UNITED STATES PATENT AND TRADEMARK OFFICE

Office Action Summary

10/583,862

DETAILED ACTION

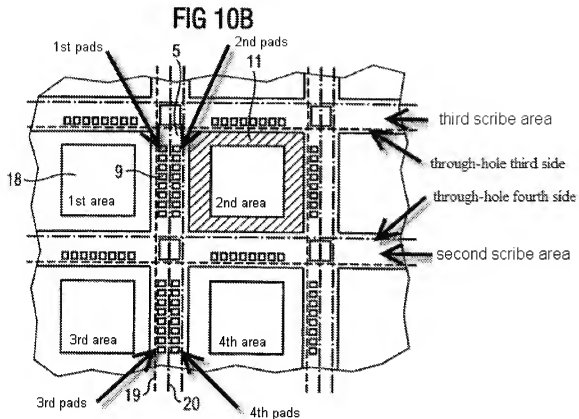
Regarding claim 1, Aigner illustrates in FIGs. 8A, 8B, 10A and 10B a device having:

a first wafer 1 having a first area and a second area opposed to each other with a first scribe area 20 in-between, wherein a first mechanical element 17 and a first pad 9 are formed in said first area and a second mechanical element (unnumbered - same as 17 on right) and a second pad (unnumbered - same as 9, just to right of 9) are formed in said second area, and

a second wafer 2 which seals said first mechanical element and said second mechanical element with a prescribed space 18 over each of said first mechanical element and said second mechanical element formed in said first wafer, wherein:

said second wafer is provided with a through-hole (5 and 19) having a first side and a second side opposed to said first side, for exposing said first pad and said second pad, and

said through-hole is so positioned that said first pad is placed between said first side and said first scribe area and said second pad is placed between said second side and said first scribe area, and

wherein said first pad and said second pad are overlapped with said through-hole when viewed in a plan view (see annotated FIG. 10B below).

Regarding claim 2, Aigner illustrates in FIGs. 10A and 10B (see annotated FIG. 10B below) said first wafer has a second scribe area

said through-hole (5 and 19) has a third side crossing said first side and said second side and a fourth side opposed to said third side,

the fourth side of said through-hole is placed between said second scribe area, said first pad and said second pad, and

the third side of said through-hole is arranged to be placed between said third scribe area, said first pad and said second pad.

Regarding claim 3, Aigner illustrates in FIGs. 10A and 10B (see annotated FIG. 10B above) said first wafer 1 has:

Regarding claim 4, Aigner illustrates in FIGs. 10A and 10B (see annotated FIG. 10B above) said through-hole (5 and 19) has a third side crossing said first side and said second side and a fourth side opposed to said third side,

Regarding claims 8 and 10, Aigner illustrates in FIGs. 10A and 10B (see annotated FIG. 10B above) said first wafer further has second through fifth scribe areas,
